JOINT REGIONAL PLANNING PANEL
Hunter and Central Coast

Panel Reference	2016HCC055
DA Number	DA/1443/2016
Local Government Area	Lake Macquarie
Proposed Development	Seniors Housing
Street Address	14 Halyard Way, Belmont
Applicant/Owner:	Bob Lander - Tattersall Lander Pty Limited / W H Hudson Developments Pty Limited
Number of Submissions	Twenty four (24) – representing over forty (40) local residents
Recommendation	Refusal
Regional Development Criteria	Private Infrastructure and Community Facility that has a capital investment value of more than \$20 million.
List of all relevant s79C(1)(a) matters	Lake Macquarie Local Environmental Plan 2014 Lake Macquarie Development Control Plan 2014
List all documents submitted with this report	Attachment 1 – Proposed Reasons for Refusal Attachment 2 – Plans of Development Attachment 3 – Clause 4.6 Variation – Height of Buildings Attachment 4 – Letter from Crown Lands Attachment 5 – Comments from Council’s Development Planner Flora & Fauna Attachment 6 – LMCC Request for Additional Information 16 November 2016 Attachment 7 – Plans of possible Amended Scheme

Report by	Andrew Leese, Senior Development Planner, Lake Macquarie City Council

Figure 4 - Extract from Lake Macquarie Local Environmental Plan 2014 Zoning Map

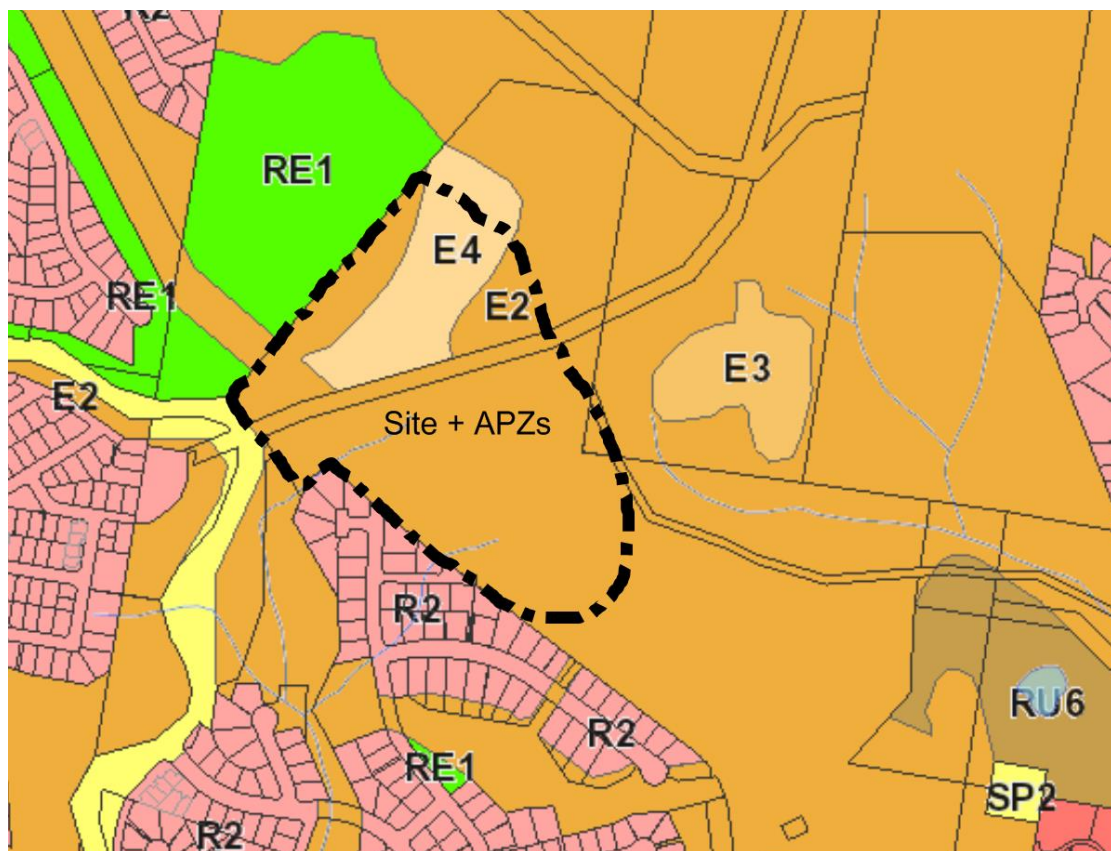
Planning Comment: The proposal fails to satisfy this objective given the adverse impact on the high ecological values of the site and surround area.

Planning Comment: The proposal fails to satisfy this objective as the proposal fails to protect and conserve land zoned E2 Environmental Conservation with high ecological value and important connectivity contribution. These values include the important link the site acts as between Green Point and other large areas of native vegetation/bush north of the site that extend north to Warners Bay and connect to areas that extend to the coast between Redhead and Dudley.

Figure 5 – Dwelling Layout

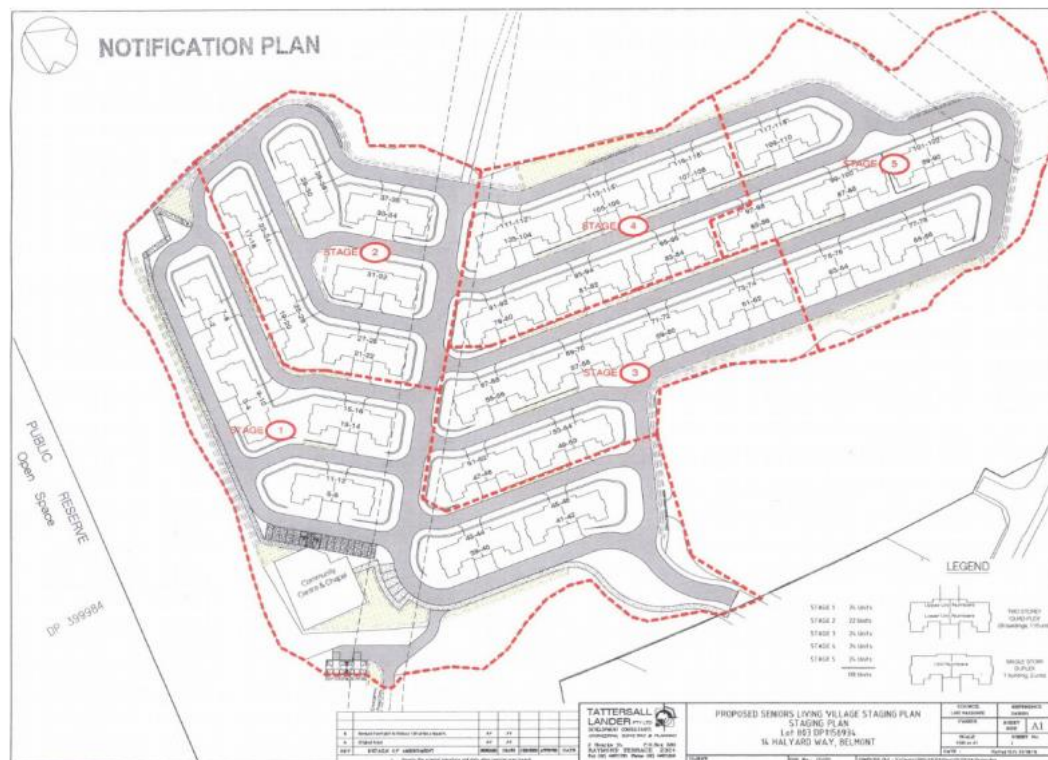
Planning Comment: The proposal is for a new seniors living development. The proposed development will exceed the maximum building height prescribed by Clause 4.3 Height of Buildings by 3.5m or 45% having an overall building height of 8m. The building height is measured from existing ground level to the top of the proposed roofs. A 45% variation is a significant percentage variation.

Planning Comment: No environmental planning grounds have been presented by the applicant to justify contravening the development standard.

Figure 8 - Geotechnical zoning

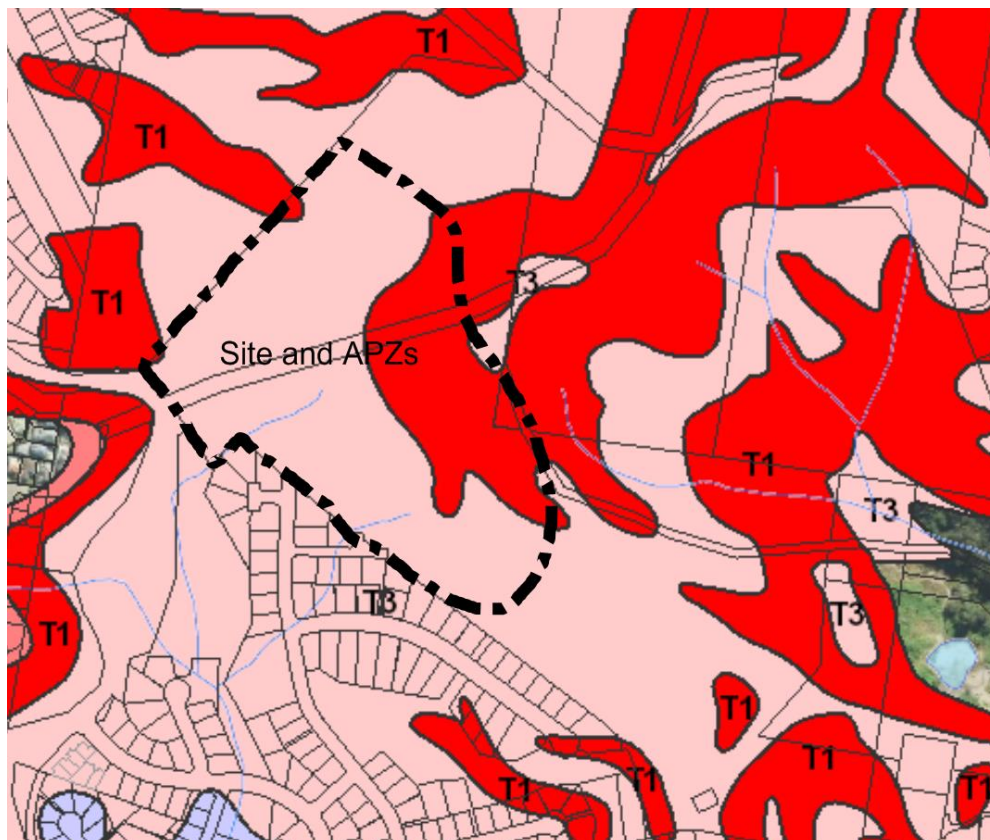
The presence of uncontrolled fill and dumped household and building waste would usually trigger a contamination assessment. This should be discussed with WER.

Further information has been requested. No information has been received.

Figure 10 - Environmental overlay of locality.

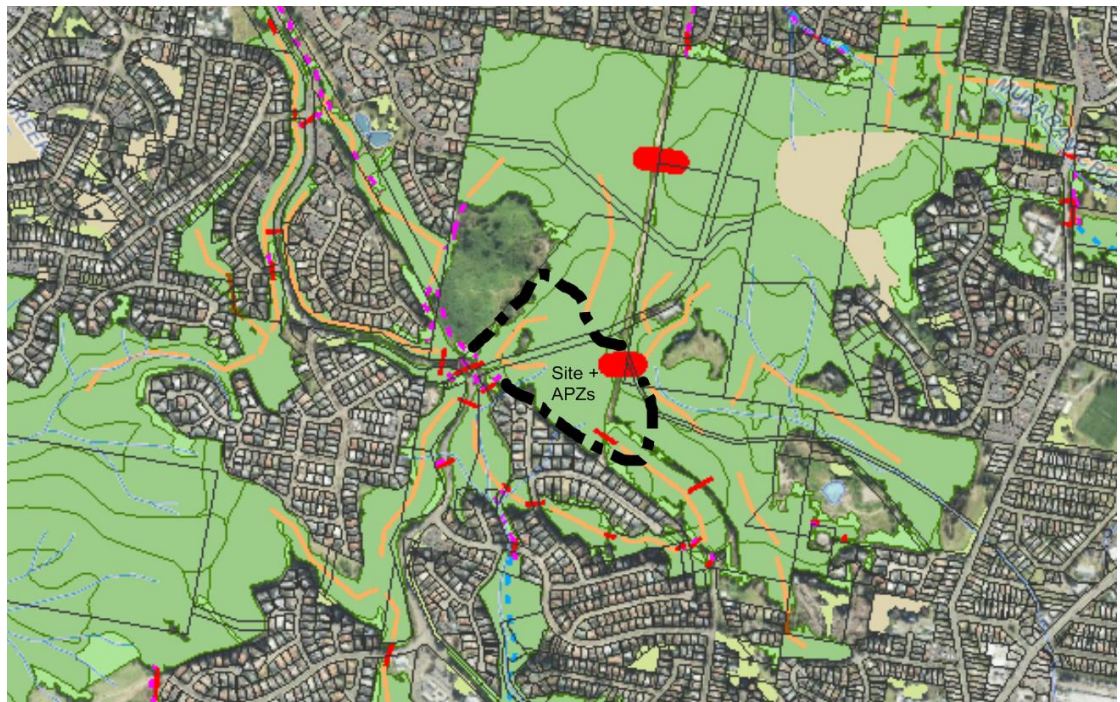
In a more strategic or landscape sense this development proposal will have implications far beyond the footprint that is proposed to be cleared. Impacts on a strategic native vegetation corridor has implications for the flora and fauna species that occupy a number of interconnected habitat patches in the north east of the LGA from Green Point to Hillsborough and Myall Road. Councils native vegetation and corridor maps show this network of patches and Councils Local Environmental Plan LMLEP 2014 contains Environmental Living and Conservation Zones in a spatial configuration to maintain native vegetation corridors and landscape connectivity across this area.

The proposal will also result in complete modification (by filling) of the headwaters of Mill creek. Despite Water quality and flow controls impacts are likely to be experienced downstream. It is not clear whether the water quality and flow control structures will be adequate to protect the ecosystem downstream.
